## TAHOE REGIONAL PLANNING AGENCY STAFF SUMMARY

Application Type: Buoy Application

Location: 2200 Lands End Drive, Douglas County

### TAHOE REGIONAL PLANNING AGENCY HEARINGS OFFICER STAFF SUMMARY

# BUOY DETAIL

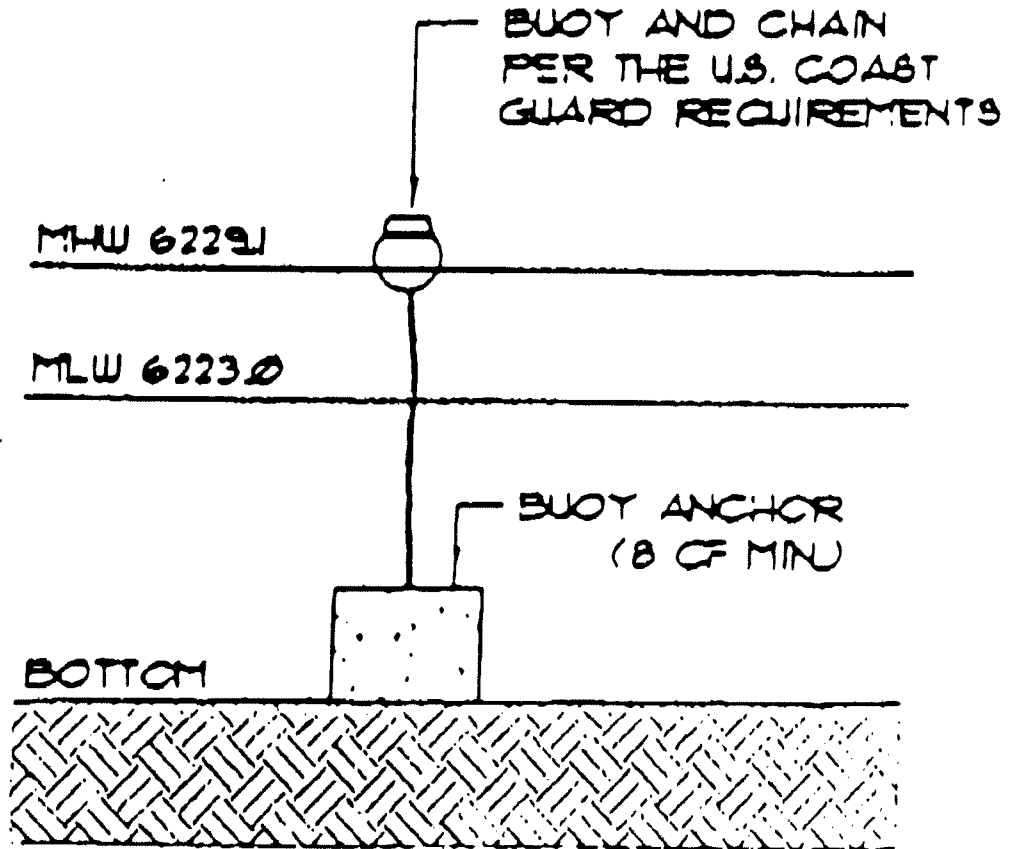
- (1) TRPA 20-foot setback lines.
    - (2) Correct identification of High and Low Water Lines on both the site and detail plans.
    - (3) A note stating that the mooring buoys will be installed by use of a barge.

**PROPOSED SITE PLAN**  
 SCALE: 1" = 60'

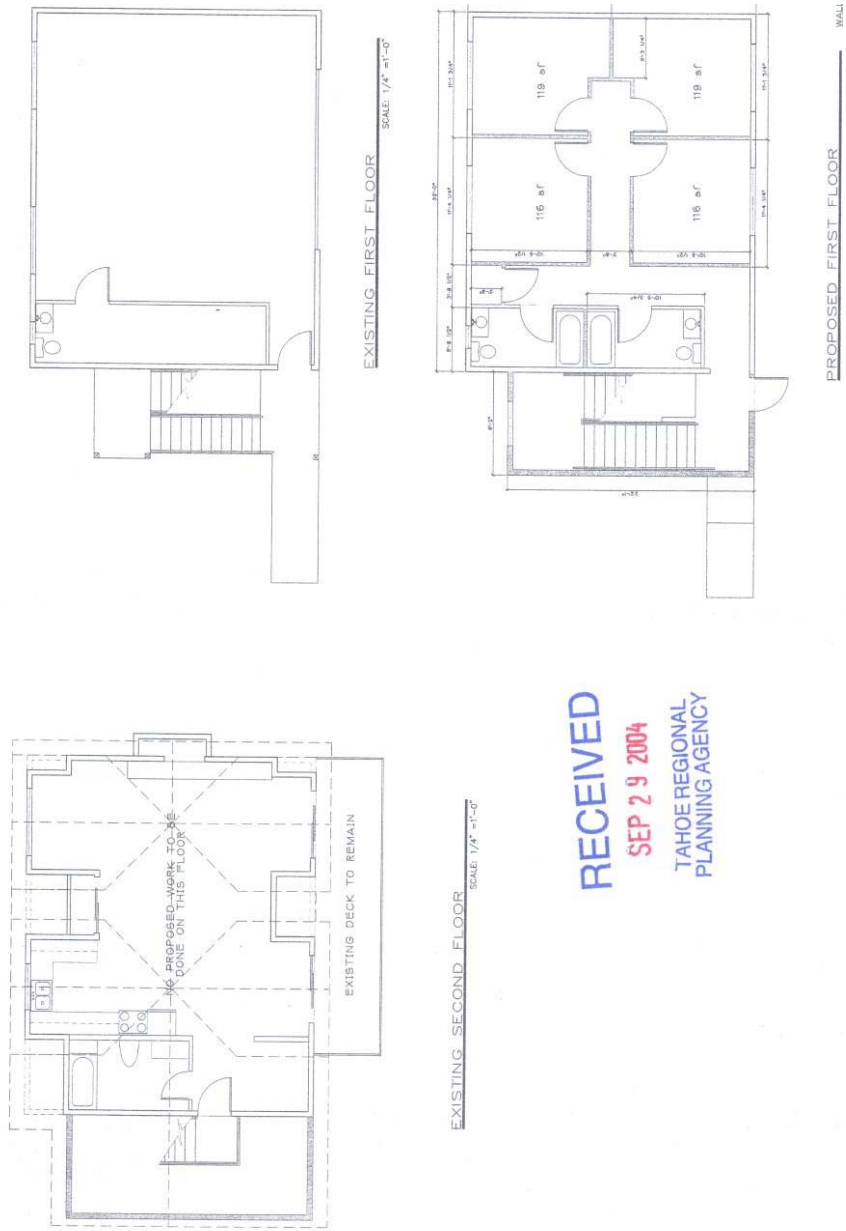
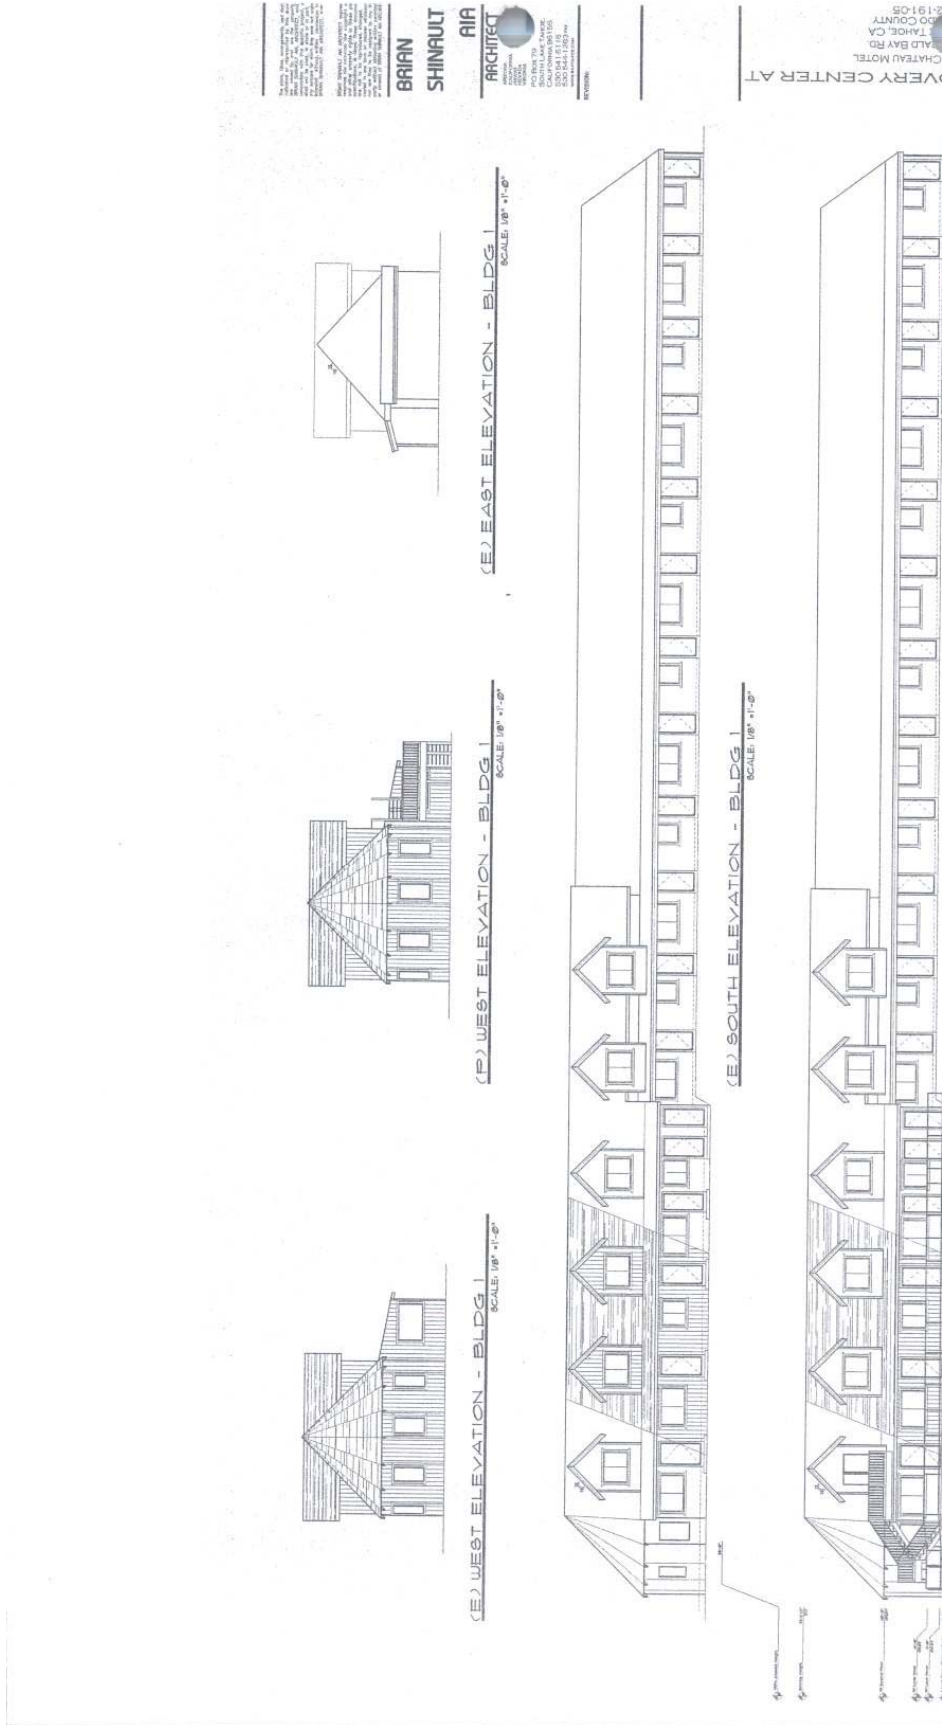
- H. The permittee shall submit a revised parking plan with evidence that the proposed parking meets the City of South Lake Tahoe parking requirements. The parking plan shall identify and provide a justification for each coverage component inconsistent with previous TRPA approvals. The justification shall be based on the needs of the public service component of the project, consistent with Section 20.3.B(6) of the TRPA Code. Any additional coverage approved shall be transferred to the site per the requirements of Chapter 20 of the TRPA Code of Ordinances and the transfer shall be limited to a maximum of 565 SF.
